Dear Sir,
Planning Application 2014/7778/P: 6 Streatley Place NW3 1HL

I wish to object to the above application on the following grounds.

From Design Statement P 26, Streatley flats to the right .

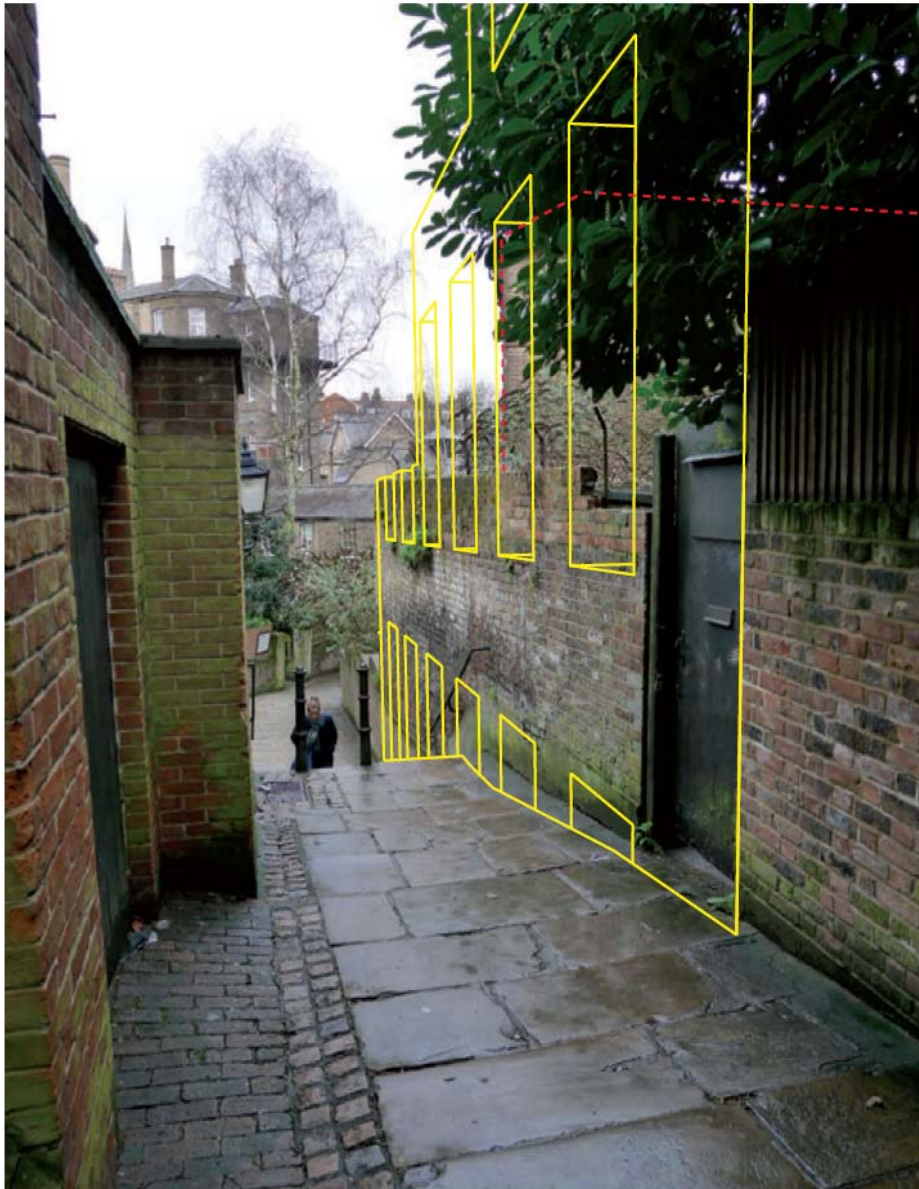
The image above is taken directly from the design statement and shows considerable massing laterally much greater than the 'old build sheds', and this new build faces directly into the main windows of the many flats in New Court.

In addition please note the two storey Victorian houses, 'Streatley Flats', to the right. Here *issues of massing*, southerly light blocking and overlook are manifest over this pedestrian access towards Streatley Flats. Also, this image could be misconstrued. Note that to the left are the pitched roofs of the existing storage sheds (shown red dashed). However to the right are taller semi circular *dashed* elements which appear to be on the site, but are actually located well beyond, up the steps beyond the next garden and are in fact a house, number 3 Streatley Place, which does not overlook the Streatley flats at all. Thus the rectangular flank massing of the proposal in this image, on the site, is much nearer and much larger than that which presently exists. The proposed North East facing flank wall to Streatley Place will also turn this part of Streatley Place into a dark canyon. This image also misses out the proposed roof level *Constable's Studio* seen on other drawings.

From the design statement, page 26

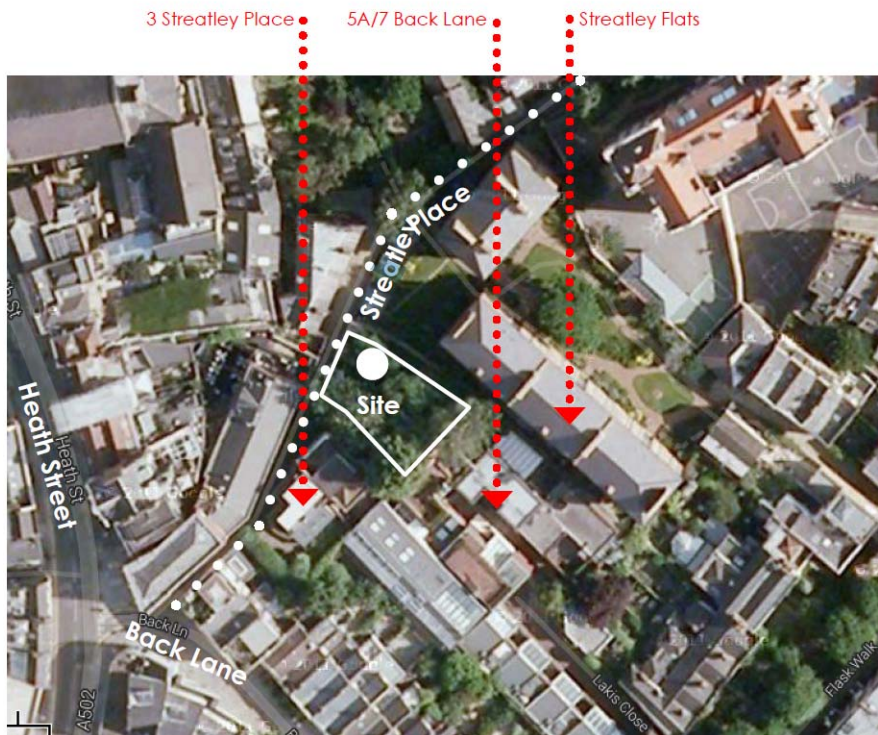
Considering this illustration, the massing on the right to this pedestrian alley is so high it would not fit in the image despite the wide angle view used. Note that there is another complete tall story (not shown here) of the new building above the old door in this image. Again it is clear that the proposal is inappropriate and out of keeping with this location.

Annotated aerial photograph showing site location and neighbouring buildings

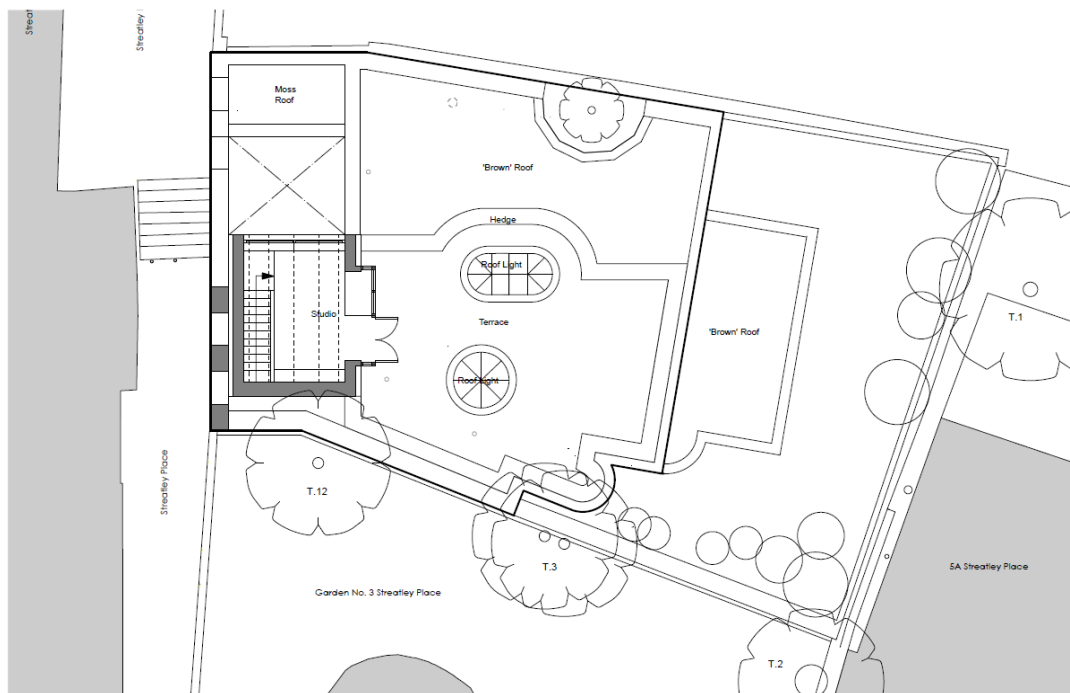
There are numerous errors of fact and description and also some confusion with the compass in some places. The above image is on the fourth page of the proposed development showing the site and its relationship to local buildings. This forms the basis of arguments about proximity and overlook and what faces what. I would point out that there are several errors which I consider materially affect the application and the arguments set out.

The passage Streatley Place is correct but '5a/7 Back Lane' is not; this is actually no 8 Lakis Close whose access is via Flask Walk. Also No 3 Streatley Place indicated is actually No 2. The 'Streatley Flats', greatly affected by the proposal, is incorrect; this is in fact one of the tall blocks of the New Court building. Streatley Flats are actually across Streatley Place, facing the site. This latter error arises from a misreading of the OS map for this locality coupled with an inadequate site survey.

Thus I fear that some of the discussion and claims about the site and buildings, and the thoughtful fitting in the new build, may refer to the wrong buildings in the wrong places. This potentially undermines the planning statements and claims about compatibility with the local infrastructure.
